APPLICATION NO.	FILING DATE	FIRST NAMED INVENTOR	ATTORNEY DOCKET NO.	CONFIRMATION NO.
10/646,611	08/22/2003	Guy Simon Dawson	37261P087	9810

Office Action Summary	Application No. 10/646,611	Applicant(s) DAWSON, GUY SIMON	
	Examiner Vinh T. Luong	Art Unit 3682

- 1) ☒ Responsive to communication(s) filed on 10 November 2005.
- 2a) ☒ This action is **FINAL**. 2b) ☐ This action is non-final.
- 3) ☐ Since this application is in condition for allowance except for formal matters, prosecution as to the merits is closed in accordance with the practice under *Ex parte Quayle*, 1935 C.D. 11, 453 O.G. 213.

ATTACHMENT

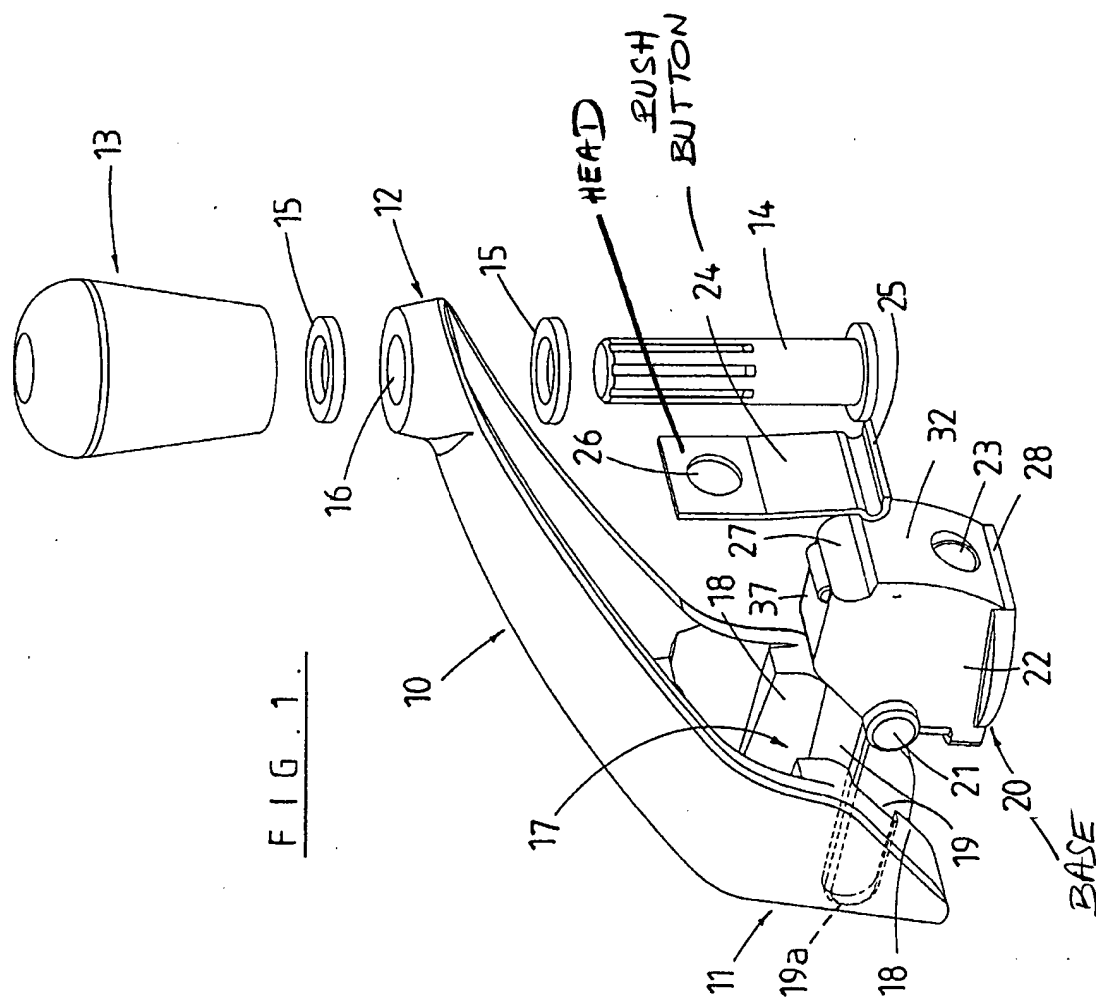
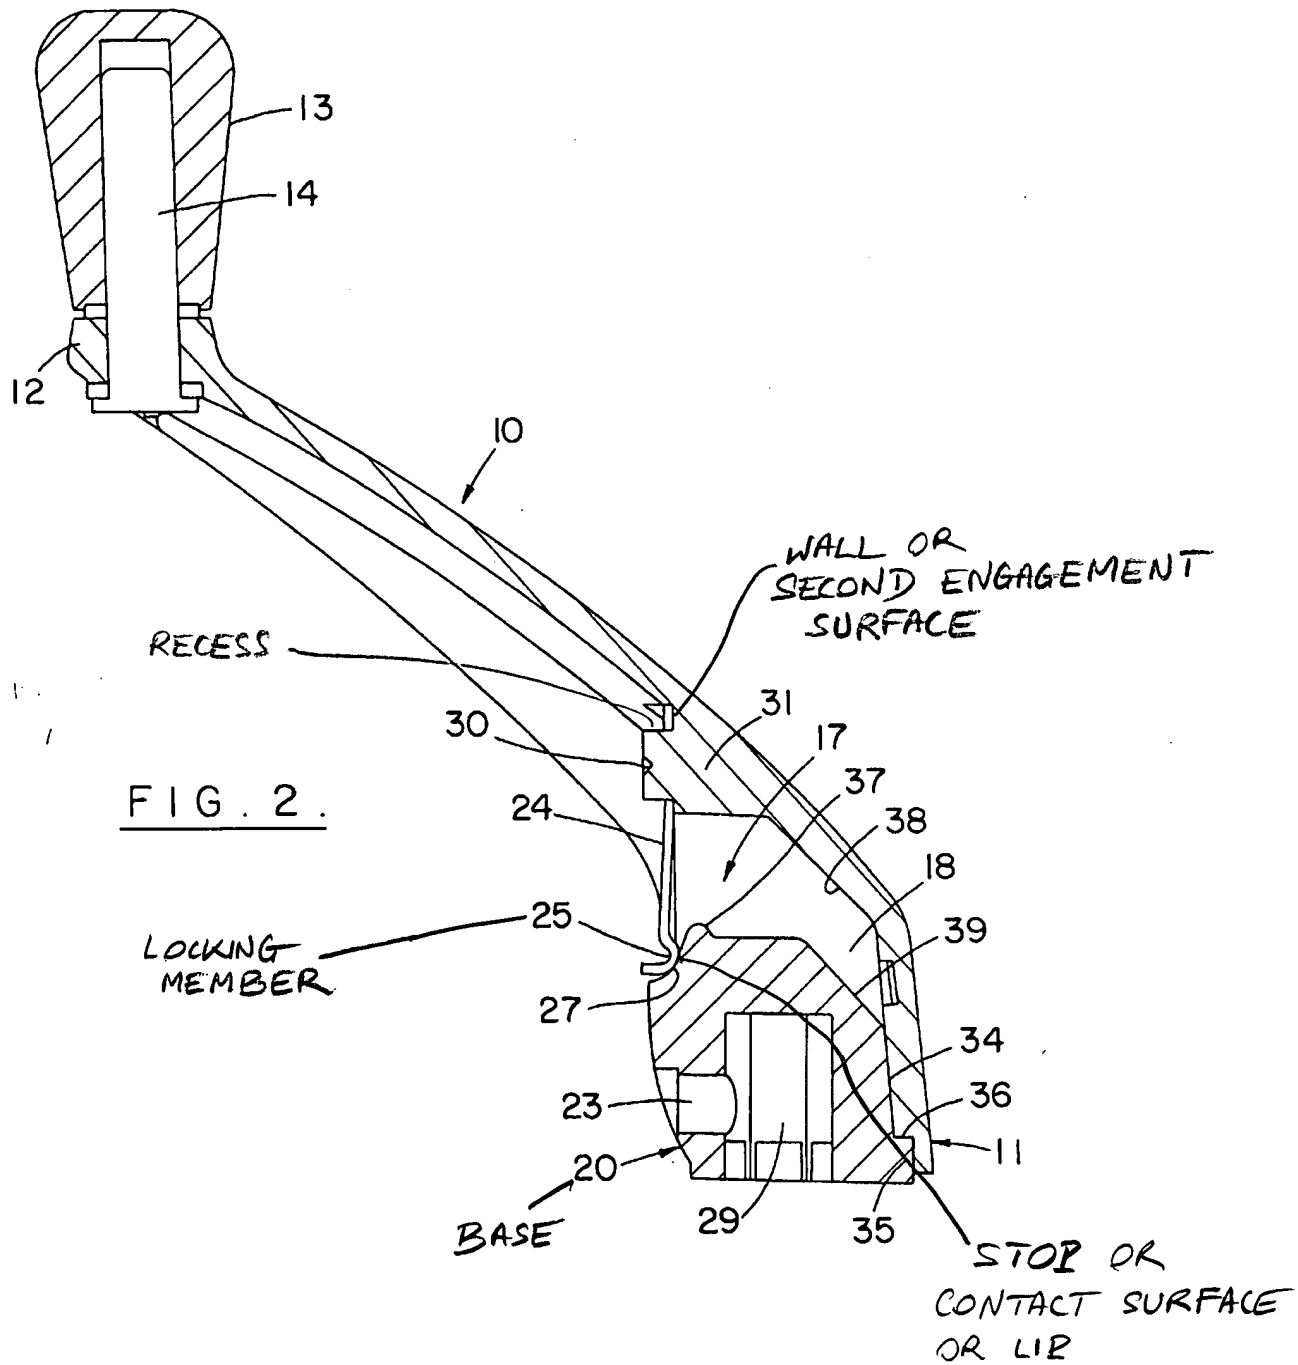
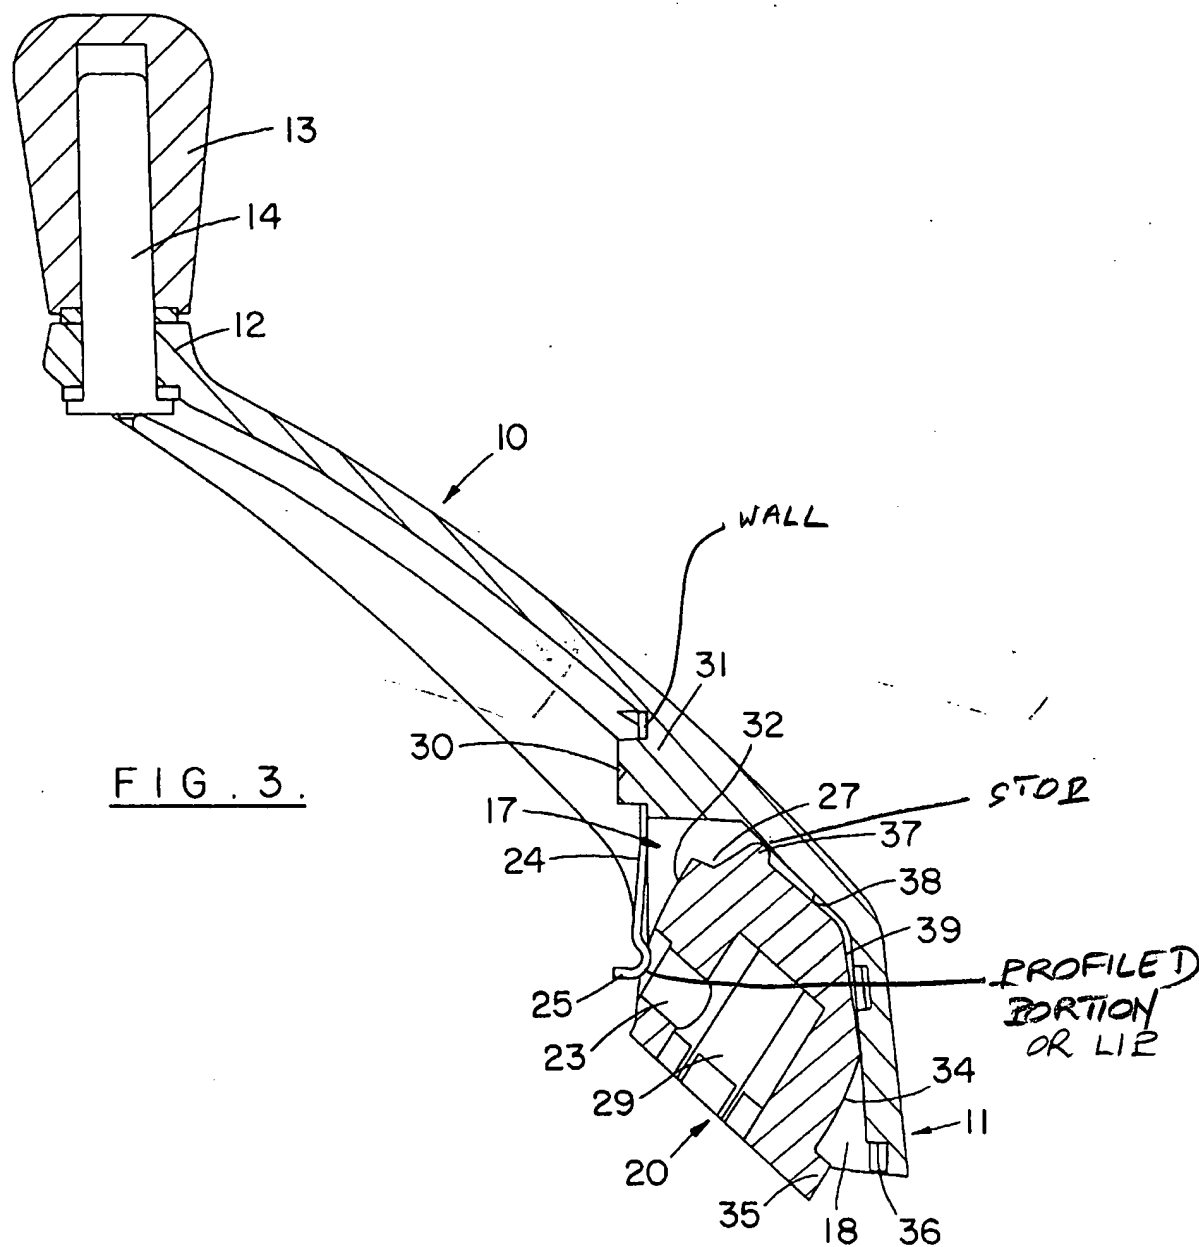
Regarding claim 2, the push button 24 includes a head (see Fig. 1 in the Attachment), which is slidably located in a recess (Fig. 2, Att.) the handle member 10.

Regarding claim 3, the peripheral shape of the recess (Fig. 2, Att.) substantially corresponds to a peripheral shape of the button 24.

Regarding claim 10, the locking member 25 includes a profiled portion 25 (Att.), which provides a clearance (at 23 in Fig. 3) between the locking portion 25 and the pivot base 20 when the locking member 25 is in the release position (Fig. 3).

Regarding claim 11, the profiled portion 25 includes a contact surface (Att.), which contacts a profiled surface 27, 28 of the pivot base 20 during movement of the handle between the first and second positions (Figs. 2 and 3).

Regarding claim 13, the recess (Fig. 2, Att.) includes a contact surface 30, which is contacted by the head (Fig. 1, Att.) when the locking member 25 is in the release position.

Regarding claim 18, the lip 25 projects from the locking portion 25. The engagement surface 30 is formed by a wall (Att., Figs. 2 and 3) in the handle member 10. The wall (Att.) further forms a second engagement surface (Att.). The locking portion 25 of the locking member 25 is located between second engagement surface (Att.) and the pivot base 20 to create the blocking action.
